Product Change Notification(PCN)

V2020B CPU heatsink, cross cut, AL6063, 14x14x10mm, BK anodized, no add. treatment

Change Notification: PCN 2018091901-V2020B

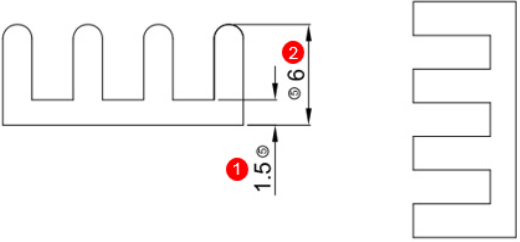
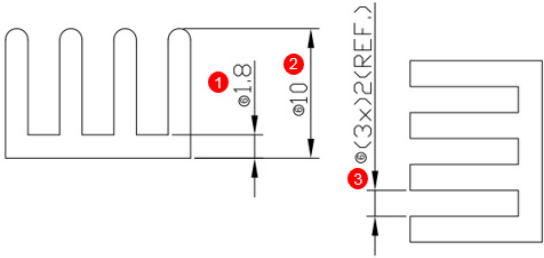
1. Change of dimensions
2. Draw.-No. ASS_0878_HSrev06 substitutes ASS_0878_HSrev05

Key Characteristics of Change: Material & Dimensions, see page 3

Reason for Change: Change of dimensions

Old version	New version
<p>1. Dimensions: (1).1.5mm (2).6mm</p> 	<p>1.Dimension: (1).1.8mm; (2).10mm; (2).Add (3x)2(REF).</p> 
<p>For detail, please take attached new drawing for reference: ASS_0878_HSrev06</p>
